September 8, 2009

RE: Master Sewer Plan Addendum No. 2

Existing Indian Hills Area  
Backbone Sewer System

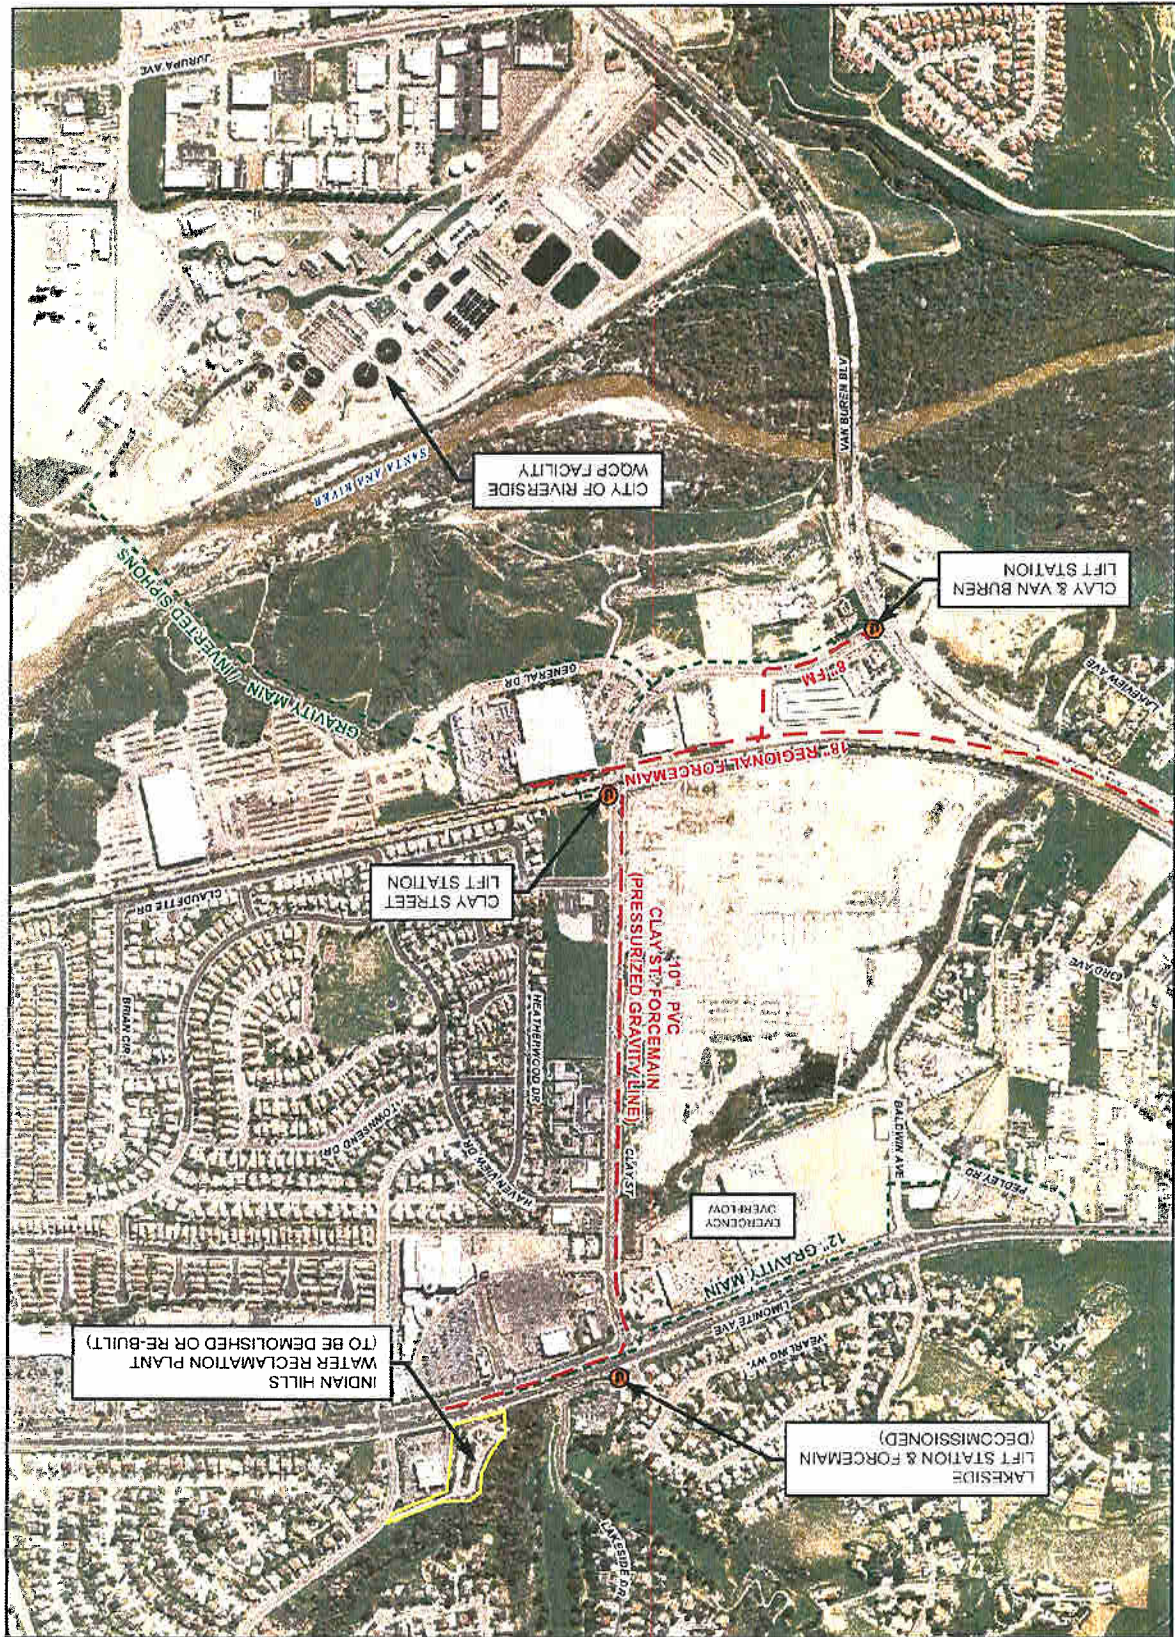
With the plan of pumping the wastewater across the new Van Buren Bridge, facilities must be proposed to transport Indian Hills Area flows (Plate 1 Tributary Areas J16, J17 and J18) to the crossing. Plate 3 illustrates the existing Indian Hills Area Backbone Sewer System. Currently, the majority of the Indian Hills Area flows enter the existing 18" Regional Forcemain by (1) a 10" dia. Clay Street pressurized gravity main (2) Clay Street Lift Station and (3) Clay & Van Buren Lift Station. The proposed Indian Hills Area Backbone System is shown on Plate 4.

**Proposed Indian Hills Area  
Backbone Sewer System**

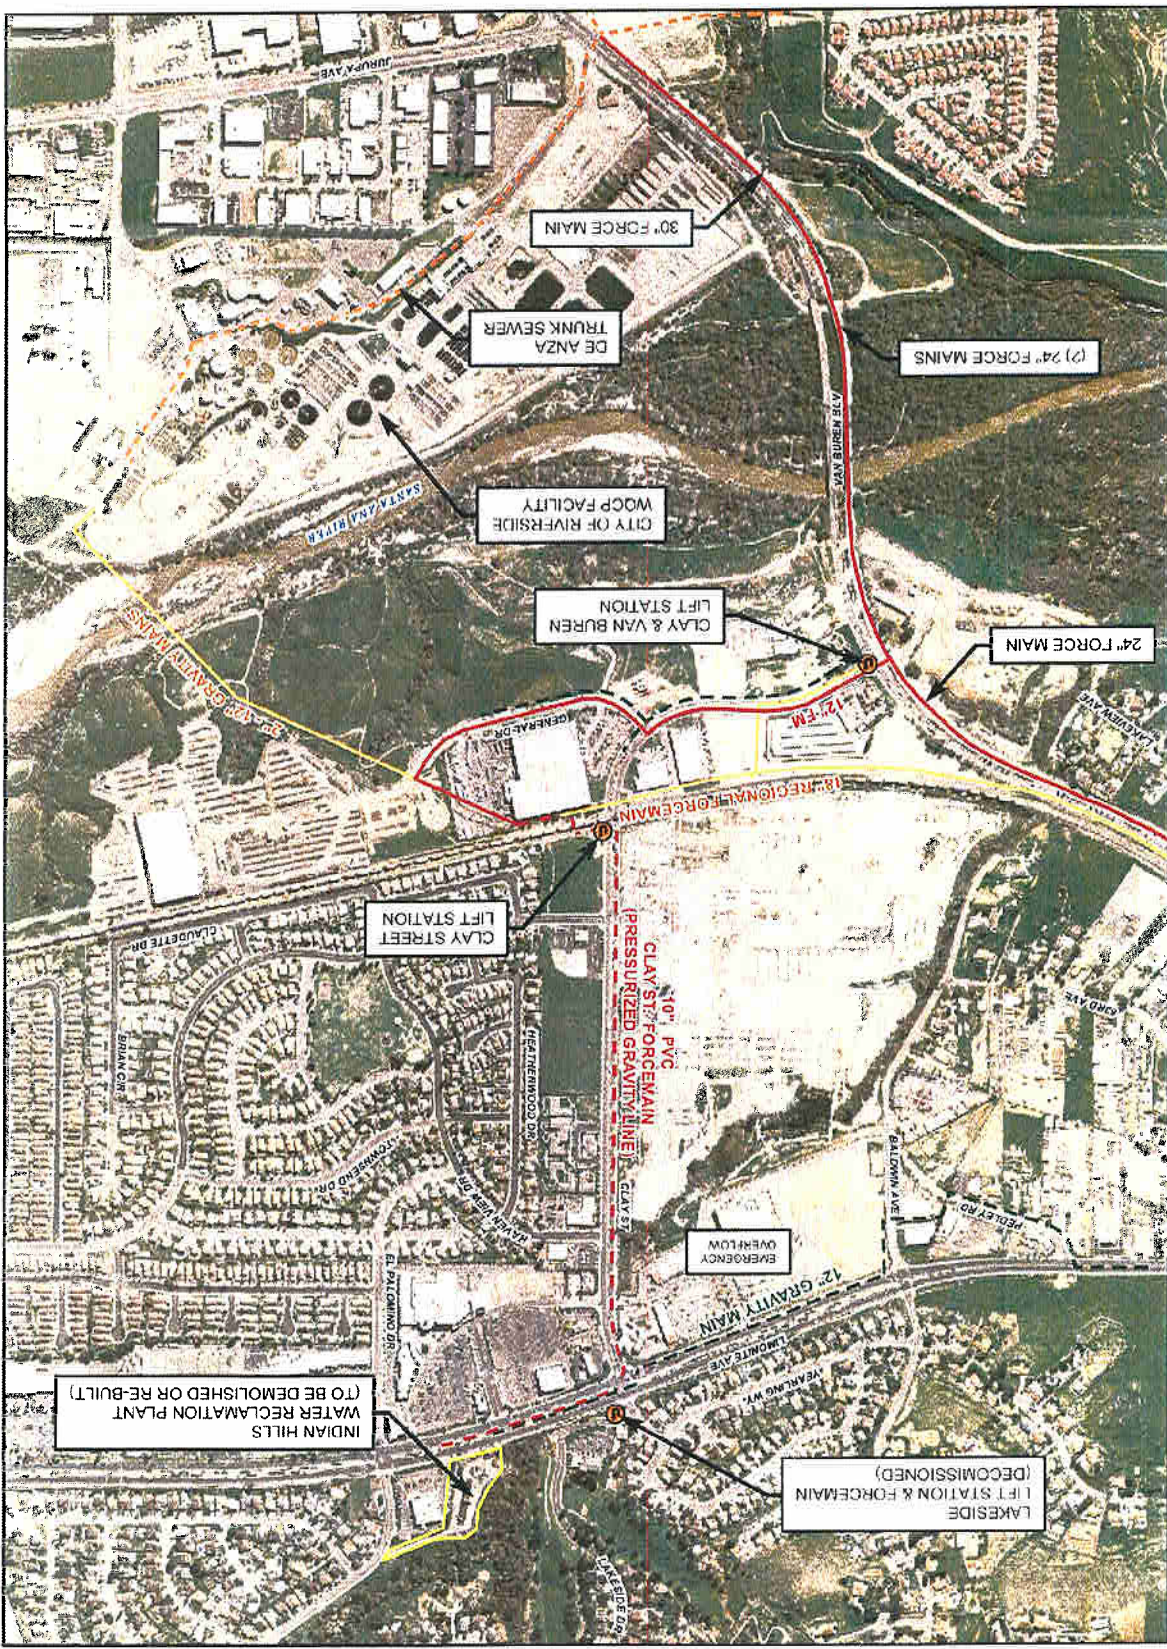
The proposed system would still utilize the Clay Street and Clay & Van Buren Lift Stations, modified for new pumping conditions, however they will now pump into a proposed 12" dia. forcemain that would traverse from the existing Clay Street Lift Station site and parallel the existing Regional Forcemain to General Drive. The proposed forcemain would then traverse along General Drive, to Clay Street and connect into the proposed 24" dia. forcemain that transitions into two 24" HDPE pipelines in a bridge crossing the Santa Ana River (Plate 2). It should be noted that due to an upcoming Clay Street/Railroad crossing grade separation project, currently in the early design phase and
